# Rickman's Green Village - Phase 1

Planning Application Ref: 22/03114/FULEIA (108 dwellings)

## Further Objections on Highway and Transport Grounds

Plaistow and Ifold Parish Council

**Diagram 1**

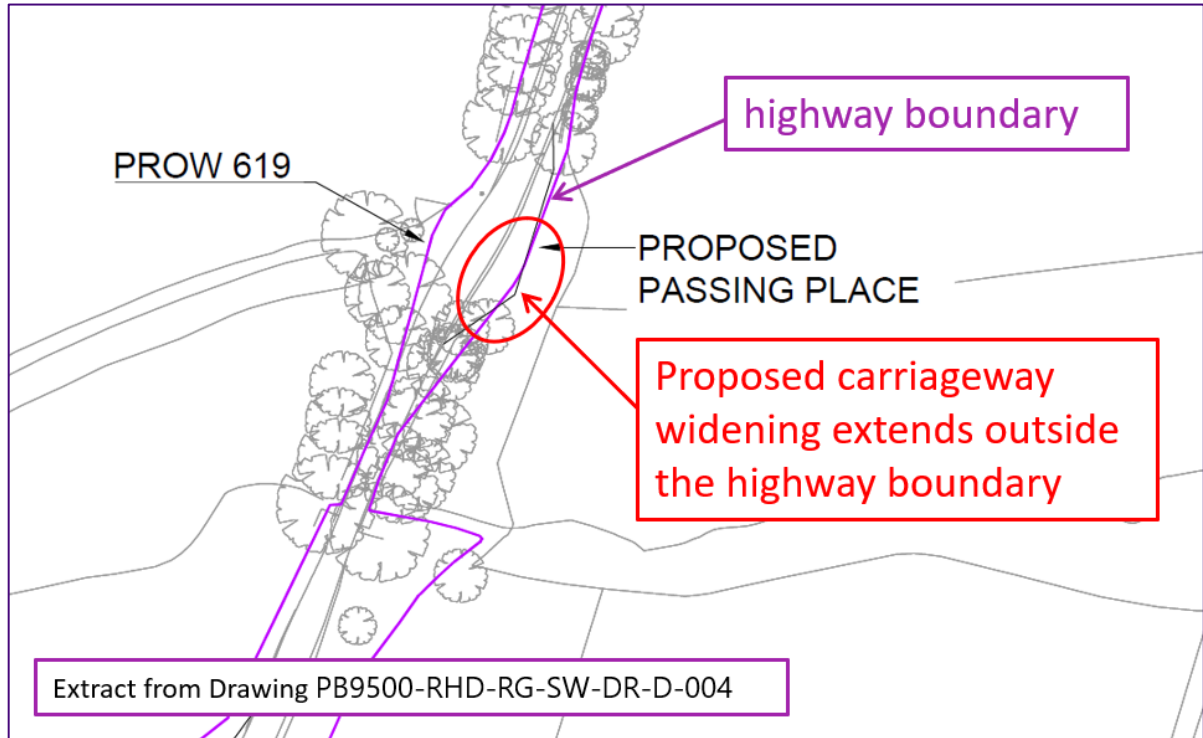
2.3.14 It is also noted that one of the passing places, opposite PROW 619 extends into third party land, beyond the highway boundary, as shown in the diagram below. It is unclear if this is a drafting error or if the applicant has secured control over the land needed for this passing place.
